Access Compliance Report

Public Rights-of-Way

(Pedestrian Signals)

Intersection ID: N/A	Main Street:	Cross Street: N/A	Location: N/A
ADA ID: 61FDE6E78D86	Signal Type: One Push Button-Non APS	Overall Compliance: No	Severity Score: BTN 1: N/A BTN 2: N/A No BTN: N/A
Codes/Mitigation Info/Possible Solution		Field Measurements/Component Compliance

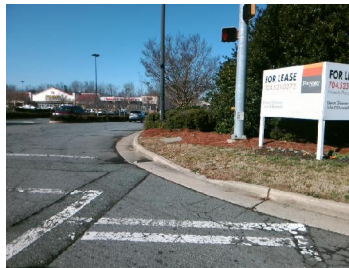
PROW/ADA: TMUTCD 4e.08, R404.3, R404.1, R404.7.1, R404.7.2

Possible Solutions: Replace Signal Push Button With APS Button on New Post. Remove & Relocate Sign.
